Re: City of Palmdale Hybrid Power Plant Project: Docket No. 08-AFC-9

IN THE MATTER OF:) DOCKET NO. 08-AFC-9
)
APPLICATION FOR CERTIFICATION,) APPLICANT’S RESPONSE TO STAFF
FOR THE PALMDALE HYBRID POWER) STATUS REPORT NO. 8
PROJECT BY THE CITY OF PALMDALE)
)
_____)

Conceptual Site Plan, Drawing No. 2007-021-CM-500, Revision D, dated 3-11-10
Figure 3-15, UFC 3-260-01, page 50, 17 November 2008

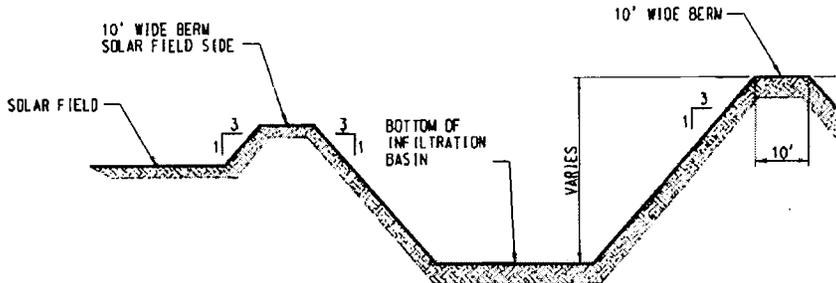
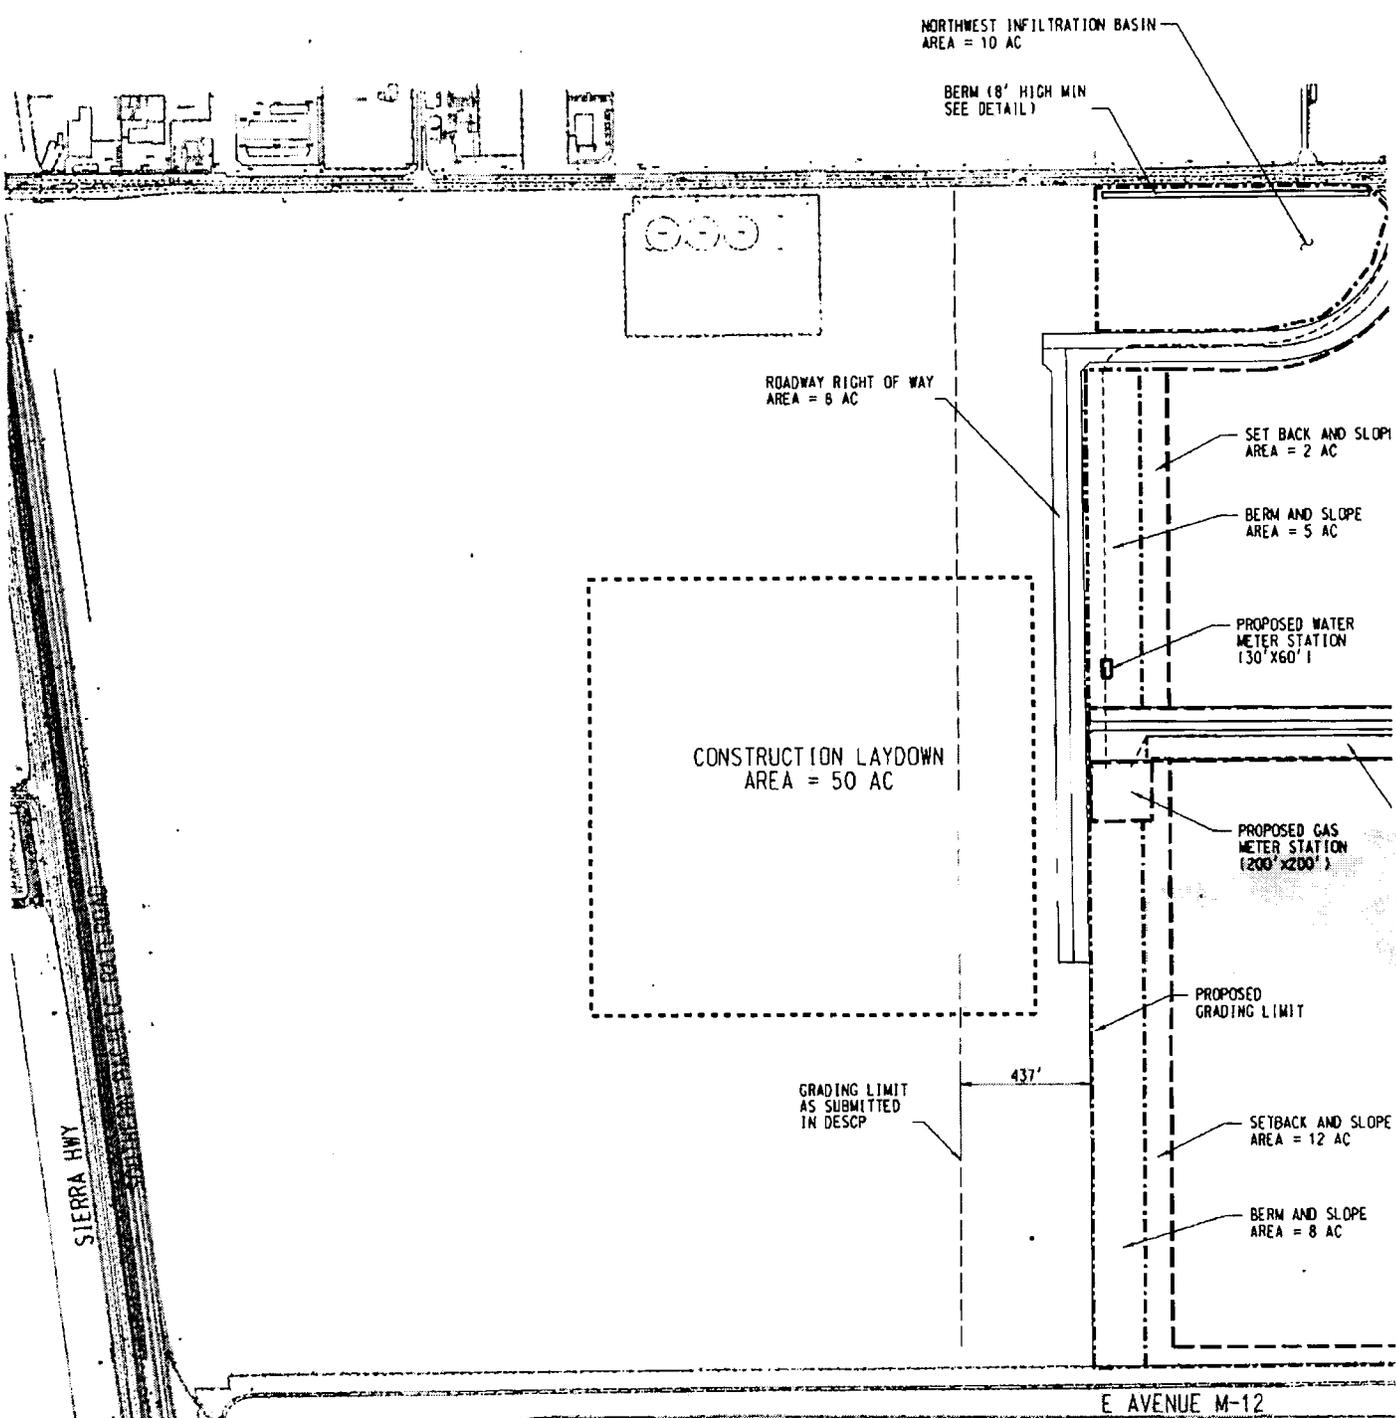
1. We have received your request to review the subject Conceptual Site Plan, Drawing No. 2007-021-CM-500, Revision D, dated 3-11-10 (attached), and have carefully reviewed it with respect to the Avenue M Earthen Berm, the Infiltration Basins, Development Setbacks, Security Cameras, Electrical Transmission Lines, Visible/Thermal Plumes and Power Plant Exhaust Stacks. The following comments are provided for your consideration.

2. Avenue M Earthen Berm: We understand the purpose of the berm (8' min.) is to mitigate the visual impacts to the north of the site, and that the berm will be landscaped with desert vegetation. We assume that dust and debris mitigation will be required on the berm (before, during and after construction). Other than the voluntary 20 feet setback from Plant 42 property line (noted herein), we take no exception to the berm as presented, and foresee no negative impacts to Air Force Plant 42 with dust and debris mitigation.

3. Infiltration Basins: We understand the purpose of the infiltration basins is to mitigate the stormwater runoff impacts from the site, that the basins will percolate/evaporate storm water runoff from the power plant property within 48 hours, that measures will be taken to ensure that the basins do not attract migratory waterfowl, and that there will be no connection to Air Force Plant 42 property. We assume that dust, debris and migratory waterfowl mitigation, will be required for the infiltration basins (before, during and after construction). We take no exception to the infiltration basins as presented, and foresee no negative impacts to Air Force Plant 42 with dust, debris, and migratory waterfowl mitigation.

4. Development Setbacks from Plant 42: Pursuant to discussions with the City of Palmdale, and as validated on the subject site plan, the site is designed to provide a development setback of 20 feet upon the power plant along the east and south boundaries of the site, adjoining Plant 42. The primary purpose of the 20 feet setback is to maintain a security standoff distance from Plant 42 property line, and that this setback will continue in perpetuity through a deed restriction or other legal mechanism on the power plant property. Other than the noted setback perpetuation, we concur with the setback as presented, and foresee no negative impacts to Air Force Plant 42.

Figure 3-15. Class B Army and Air Force Runway Airspace Plan and Profile
Runway Imaginary Surfaces

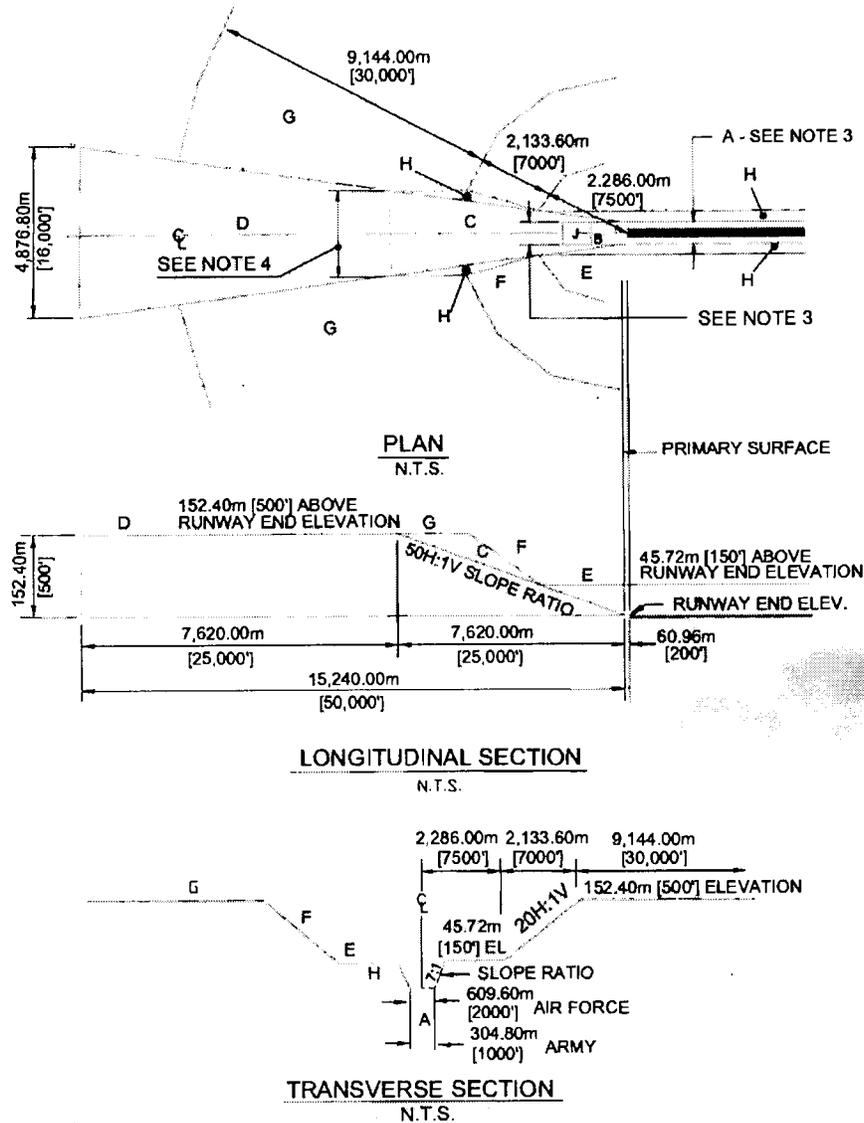
- d. Alternative Route 3: Along Sierra Highway, near Avenue N, the poles are approximately 3,600 feet from Plant 42 Runway 07 Approach End (west end of Runway 07-25) within Plant 42 Accident Potential Zone I (APZ I). Pursuant to Figure 3-15 of UFC 3-26-01, these poles are within Plant 42's military airport airspace. It is our understanding that the City of Palmdale

intends to restrict all poles, within Plant 42's military airport airspace, to single pole structures no greater than 120 feet in height, and that the system along Sierra Highway within the military airport airspace would be undergrounded, thereby eliminating the potential conflicts to the airport; if the transmission lines are not undergrounded, these poles would have to be restricted to a height of 68 feet above the runway elevation of 2543 MSL at the most critical locations. While there are inherent risks with any above ground structures located within airport flight paths, this alternative route, if not undergrounded, would pose a greater risk than Alternative Route 2.
